Project: LELY GOLF ESTATES BEAUTIFICATION, M.S.T.U. **Landscape Observation Report:** May 2019
Location: MSTU DISTRICT ROADWAYS
Project Manager: Dan Schumacher, Collier County Public Services Division, Public Transportation & Neighborhood Enhancements Department
Consultant: McGee & Associates **Consultant's Representative:** Michael A. McGee, rla, isa
Contractor: Commercial Land Maintenance **Contractor's Representative:** Robert Kindelan, Gary Gorden
Report Date: FY18-19, 5/7/19 **Observation Date:** 5/7/19

Report No. 8

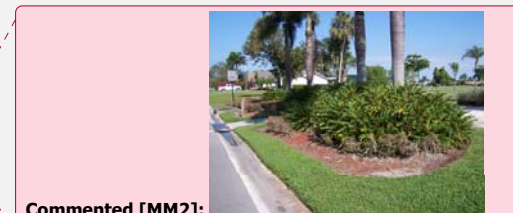
4	Auto accident on east end of median in Juniper plants. (6-7) plants damaged and need to be removed. Recommend removing Juniper back to light pole and install Perennial Peanut on end. (45-50) 1 gal. plants required. (photo)	
<u>Median #5</u>			X	19	At address 164: (2) Queen's crape myrtle leaning.	Reset and stake.
<u>Median #6</u>	X	X	X	6	At address 228: Recommend installing (3) Alexander palms, Add (2) between existing Washingtonia palms and (1) west of westernmost Washingtonia palm. Field grown B & B with double 10 ft. clear trunks. Align trunks with median. Will require (3) bubblers locations with (2) adjustable flood bubblers per tree.	Committee Approved: _____
	X	X	X	7	At address 246: Recommend installing (3) Alexander palms, Add (2) between existing and removed Washingtonia palms and (1) east of easternmost Washingtonia palm. Field grown B & B with double 10 ft. clear trunks. Align trunks with median. Will require (3) bubblers locations with (2) adjustable flood bubblers per tree.

Lely Golf Estates Beautification MSTU Reuse Mixing Chamber Annual Water Use thru 4/19

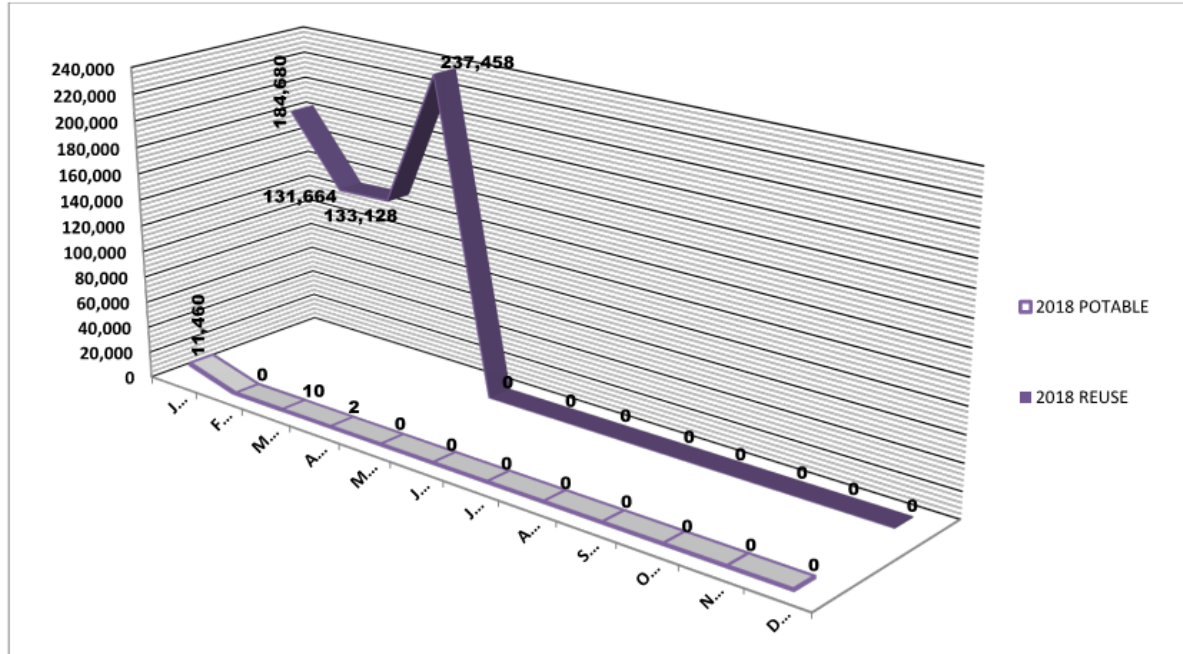
Notes: 2014 Total Water Use: Reuse-2,336,976 gallons, Potable- 0
 2015 Total Water Use: Reuse - 1,795,449 gallons, Potable - 8,602 gallons
 09/2016 Potable water meter readings not complete. 11/9/16 Meter cleaned and readable
 2016 Total Water Use: Reuse 936,041 gallons, Potable 7,788 gallons.
 2017 Total Water Use: Potable water amounts amended to corrected totals. Reuse 594,189 gal., Potable 981,815 gal.
 2018 Total Water Use: Reuse 1,965,840 gallons, Potable 270,200 gallons
